Item Name: Upper Cutter Assy

ENGINEERING CHANGE NOTICE NO.

DWG NO. 646.3300

DWG TITLE: UPPER CUTTER ASSY

SHEET 5 IS:

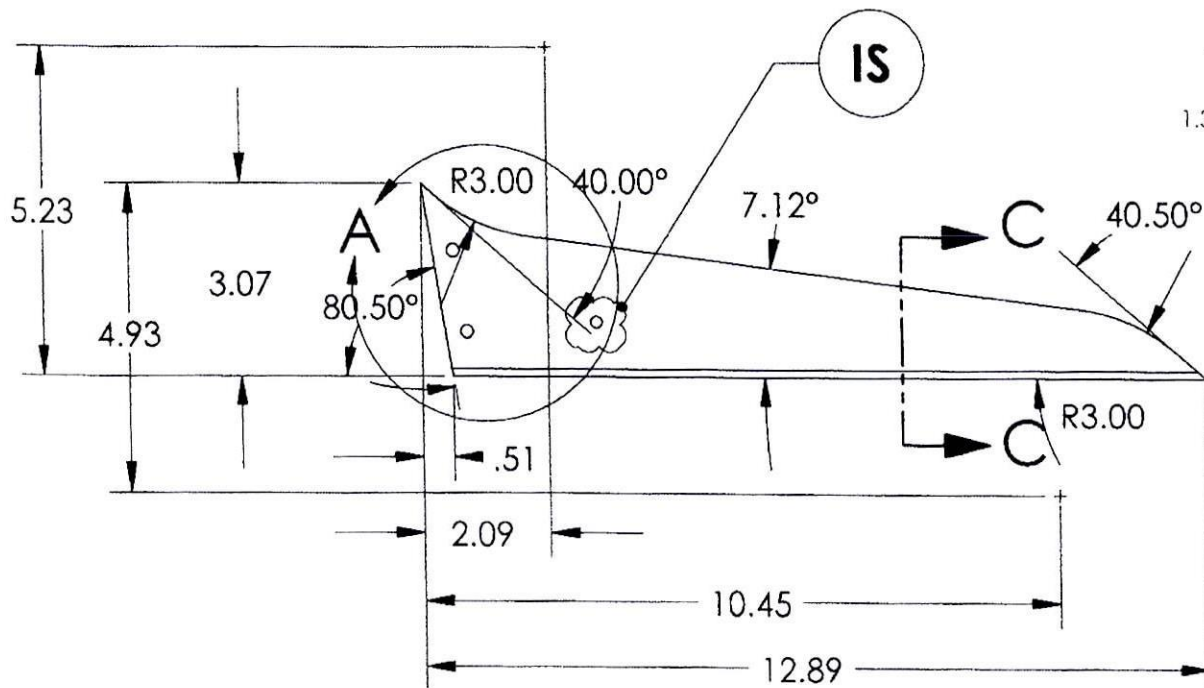
REASON: ADDED HOLE DIMENSION TO 646.3313.

SHEET 4, ZONE B8 IS:

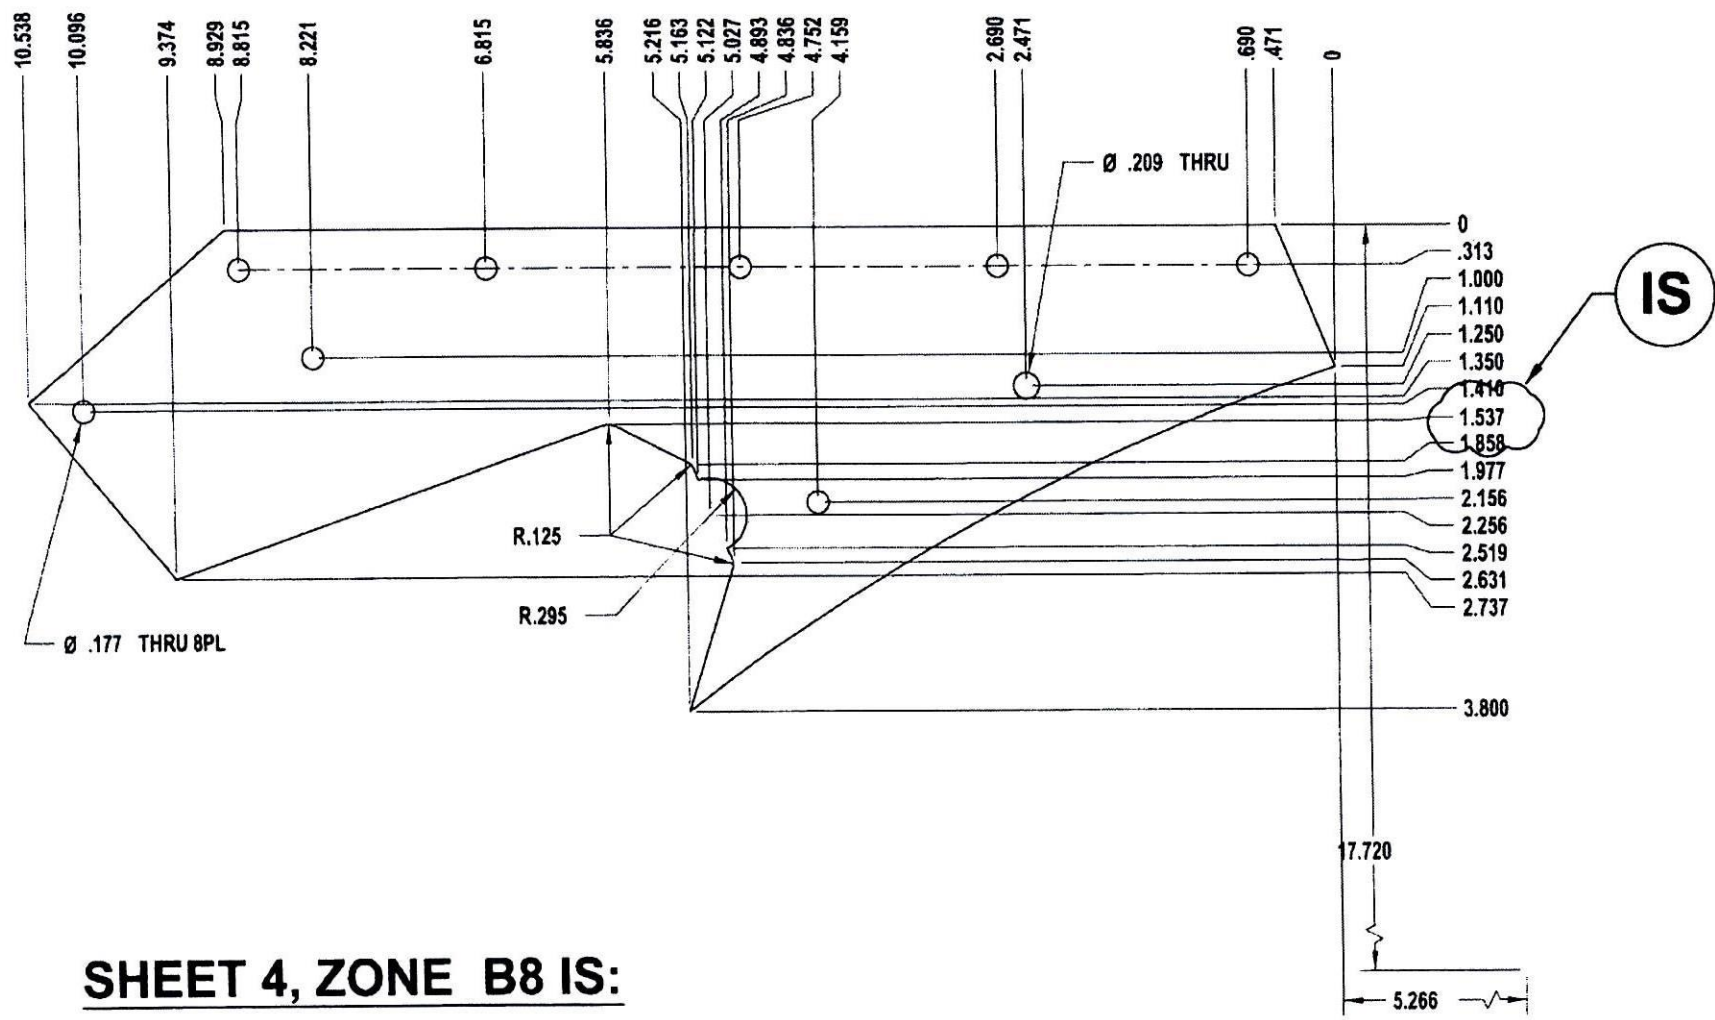
APICAL INDUSTRIES, INC.	ENGINEERING CHANGE NOTICE NO. 03724				SHEET 1 OF 1	
	DWG NO. 646.3300	REV: N/C	PREPARED BY: B. PETERS	DATE: 12/05/12	EFFECT ON DWG ☐ INC. ☒ UNINC.	
	DWG TITLE: UPPER CUTTER ASSY					
	APPROVED BY: ENGR <i>[Signature]</i>	MFG <i>[Signature]</i>	QC <i>[Signature]</i>	EFF: NEXT ORDER		
TRANSACTION CODES (TC): A-ADD C-CREATE R-REVISE D-DELETE	REASON: REVISED ORDINATE DIMENSION.				ECR: D-12-025

SHEET 1, VIEW 646.3301, IS:

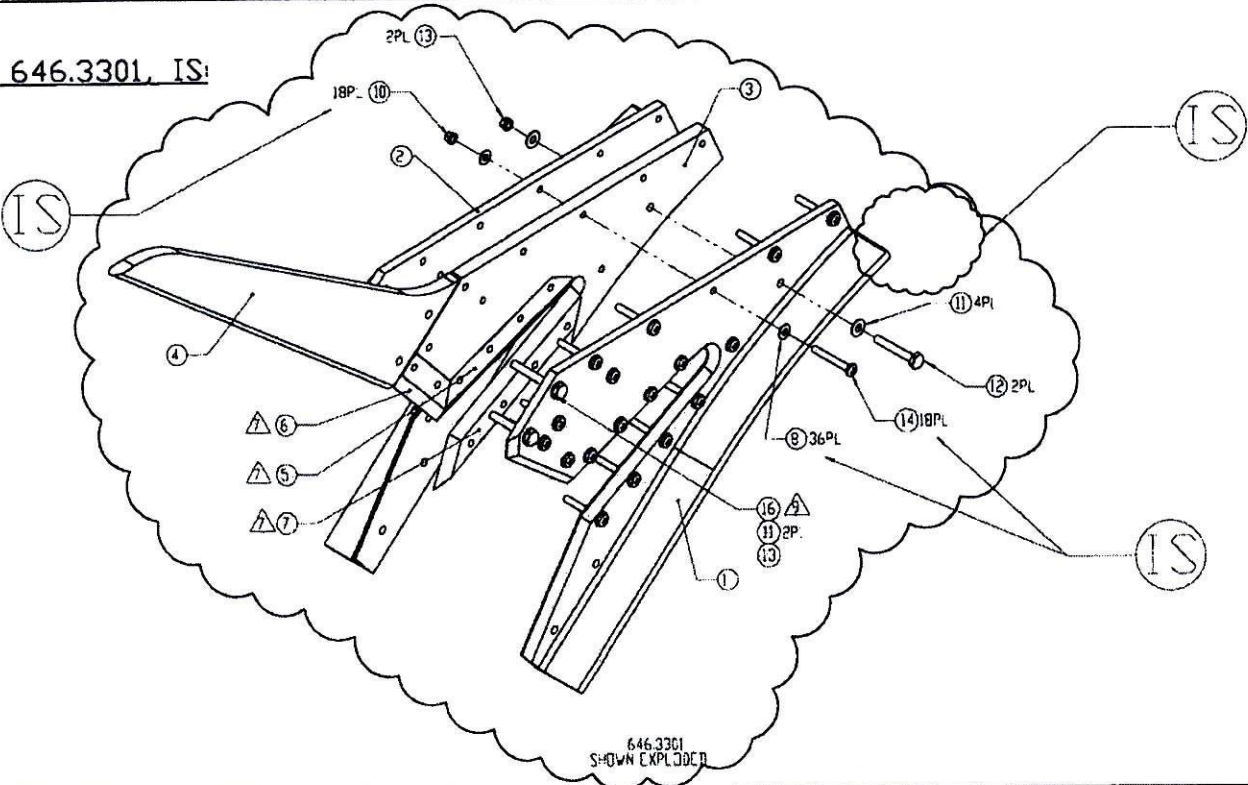
APICAL INDUSTRIES, INC.	ENGINEERING CHANGE NOTICL NO. 02196				SHEET 1 OF 2	
	DWG NO. 646.3300		REV: N/C		PREPARED BY S. HUFF	
	DATE: 01/05/09		EFFECT ON DWG ☐ INC. ☒ UNINC.			
	DWG TITLE: UPPER CUTTER ASSY					
APPROVED BY: ENGR <i>[Signature]</i>		MFG <i>[Signature]</i>		QC <i>[Signature]</i>		EFF: NEXT ORDER
TRANSACTION CODES (TC): A-ADD C-CREATE R-REVISE D-DELETE						
REASON: REMOVED RIVETS IN FAVOR OF ADDITIONAL SCREWS

14	R	601.2765		18	SCREW	MS27039-0819
10	R	601.1541		18	LOCKNUT	MS21042L08
9	D	601.2766		3	RIVET	MS20470AD5-18
8	R	601.2764		36	WASHER	NAS1149FN832P
				.3301		
F/N	TC	PART NUMBER	QTY	DESCRIPTION		MATERIAL/SPECIFICATION
DOCUMENTS EFFECTED:						CHANGE CATEGORY
☐ MDL ☒ INSTALL INSTRUC ☒ ICA ☐ FMS ☒ BOM						DER REVIEW REQUIRED
						☐ MAJOR ☒ MINOR
						☐ YES ☒ NO
